# **FINAL (MYO) BASELINE MONITORING REPORT** **SIX RUNS STREAM AND WETLAND MITIGATION PROJECT**

NCDMS Project #100170  
DMS Contract #0303-01  
RFP: 16-20190303 (Issued 12/20/2019)  
USACE Action ID: SAW-2020-01964 | DWR Project #20201798 v1

RE: DMS Comments on the MY0 Report Six Runs, Project ID #100170, DMS Contract #0303-01, RFP 16-20190303

Listed below are comments provided by DMS on July 31, 2023 regarding the Six Runs Stream and Wetland Mitigation Project As-built and MY0 Baseline Monitoring Report and RES' responses.

SHEET NUMBER:  
**S7**

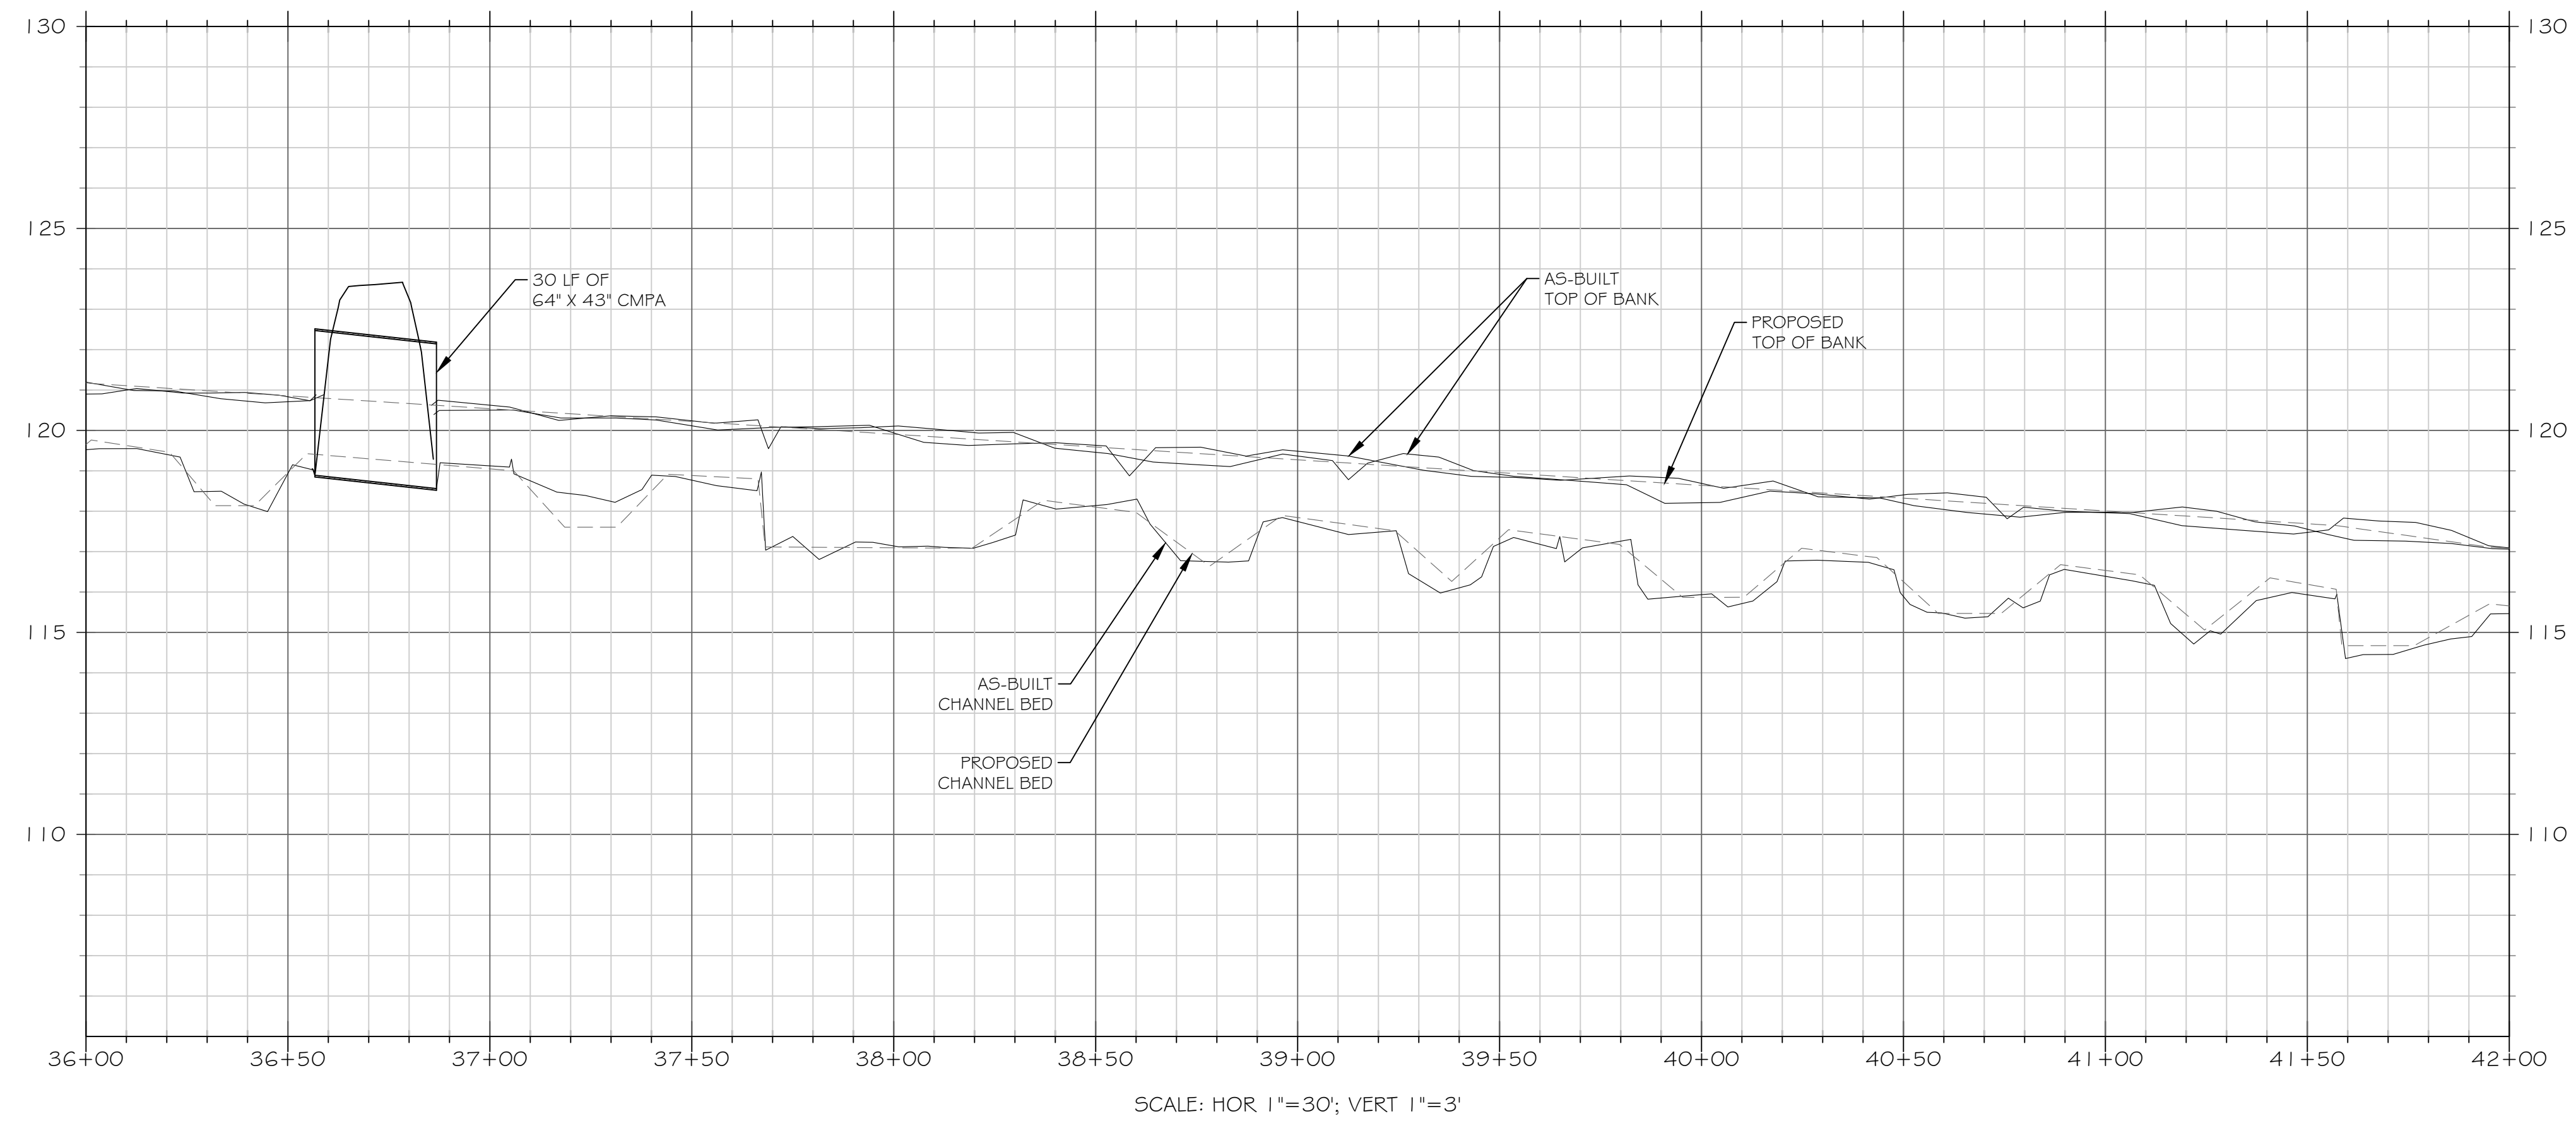
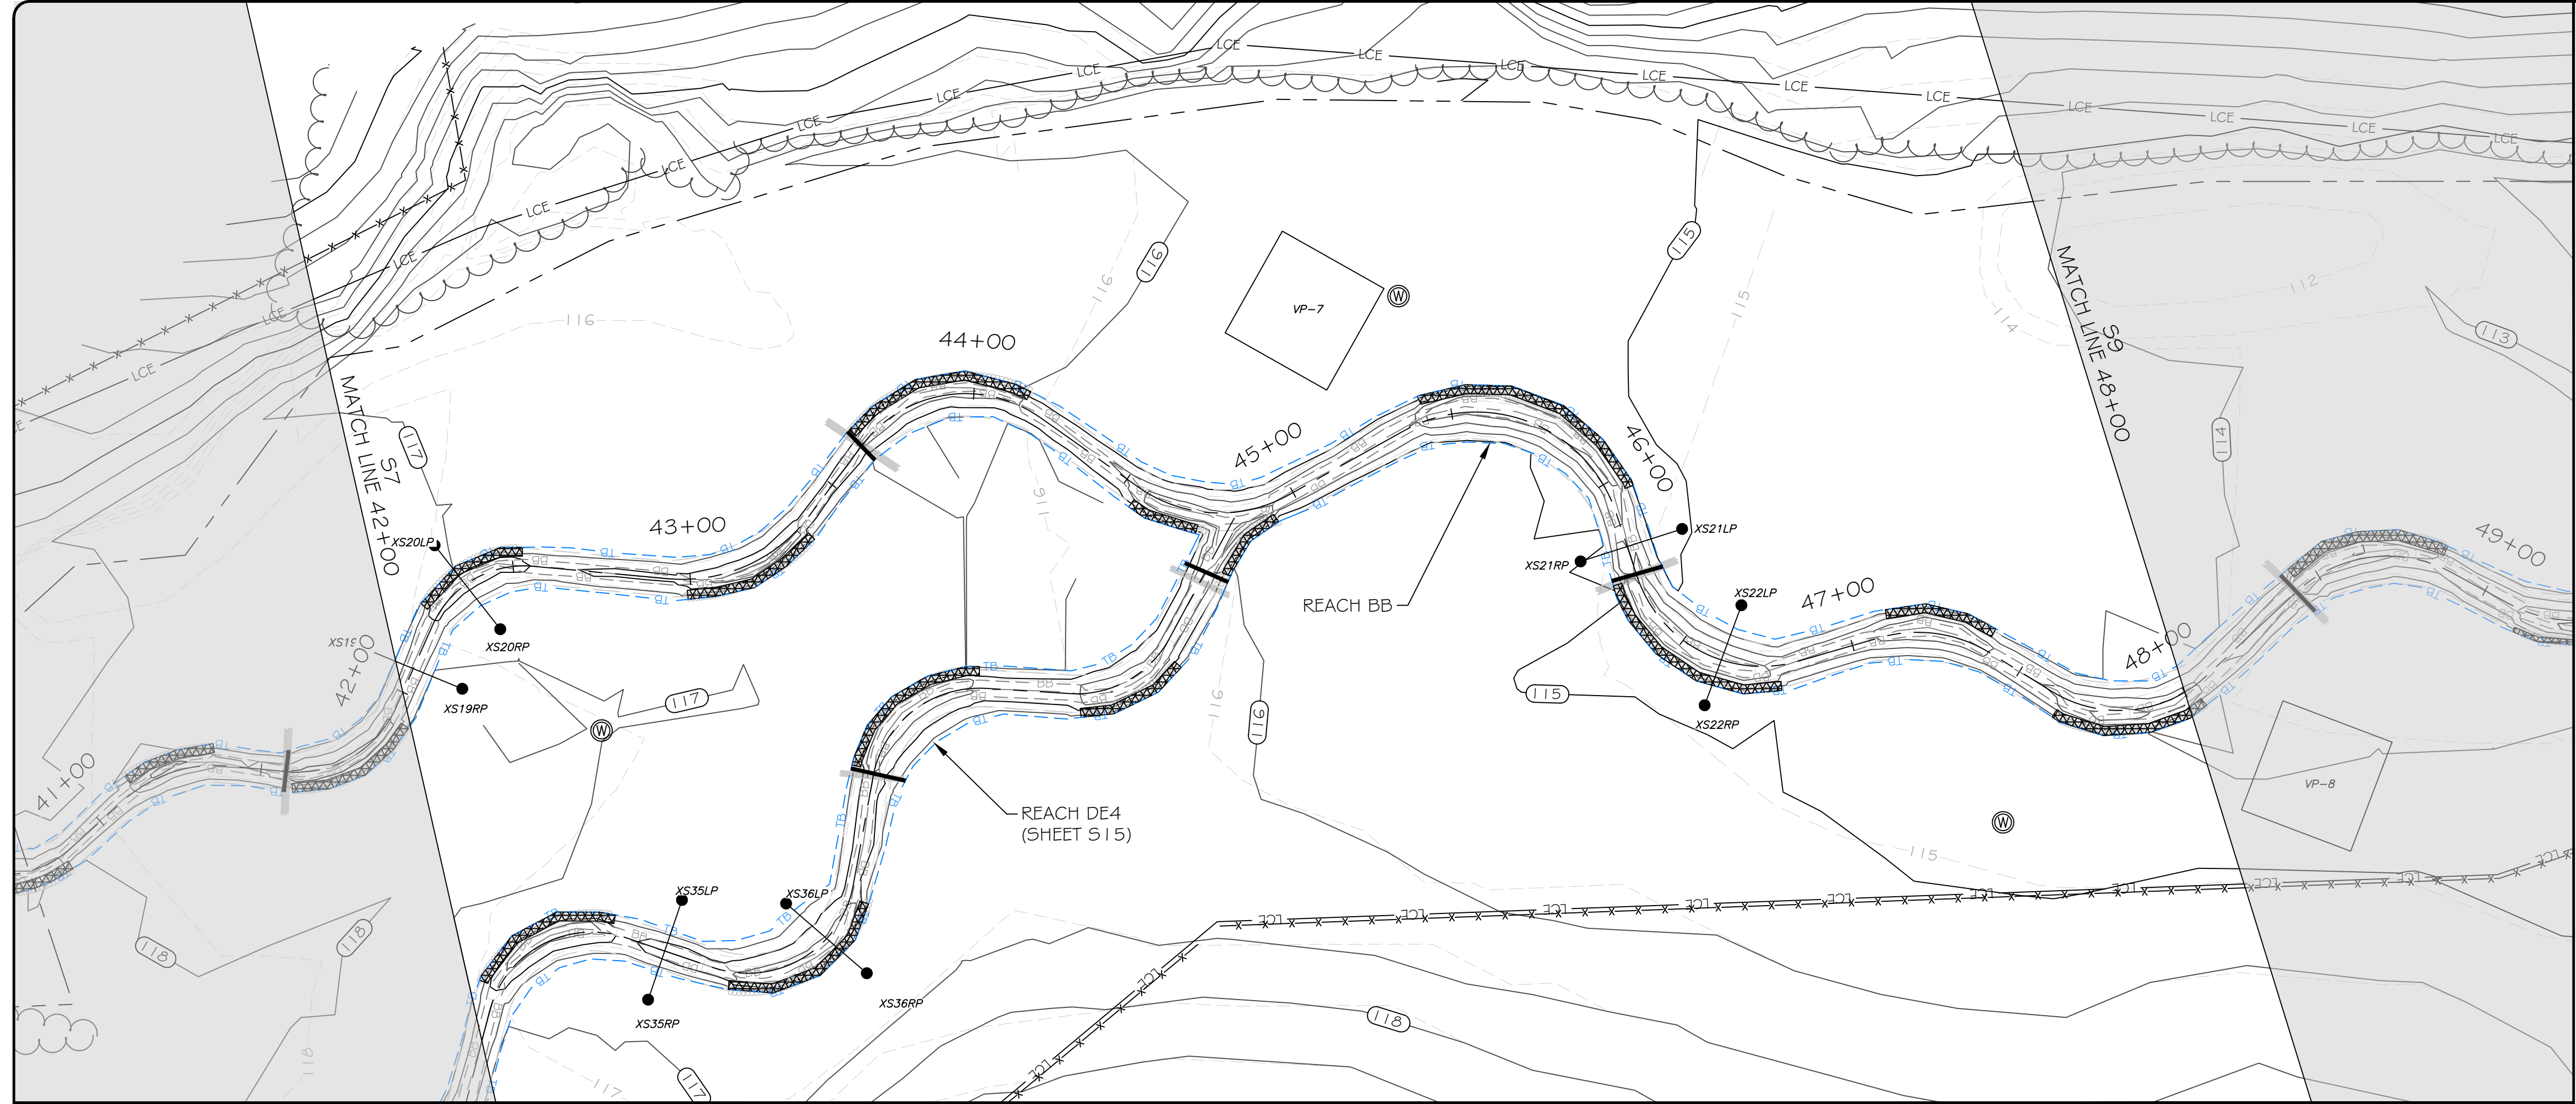
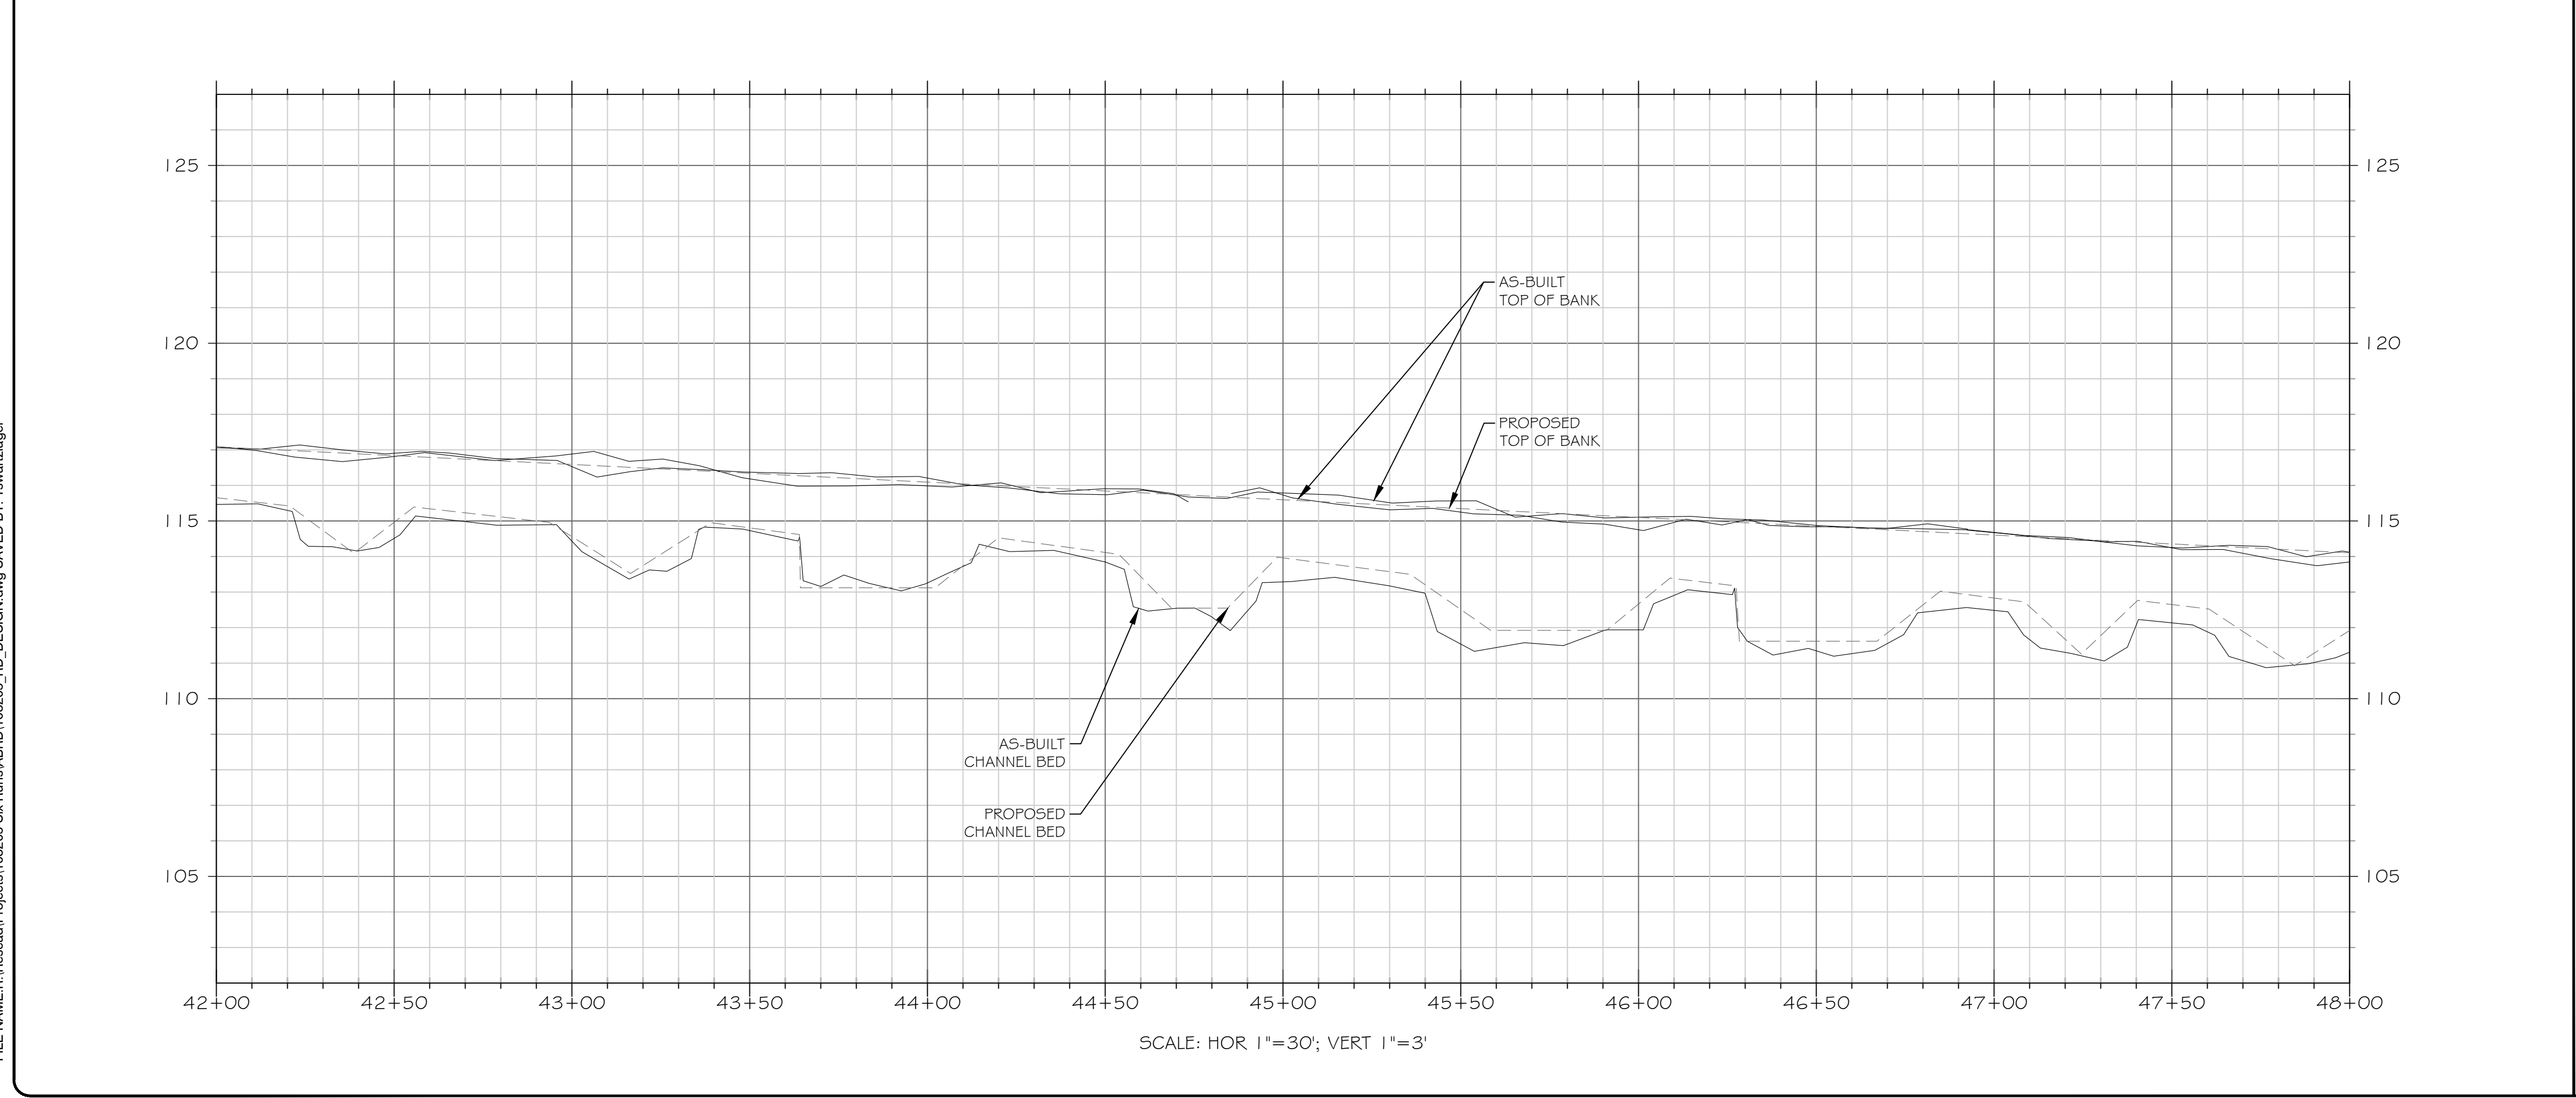
12. Sheet S7 – Immediately downstream of Sta. 37+00 a stone toe was installed in place of a brush toe and should be called out.  
Red callout has been added for the stone toe.
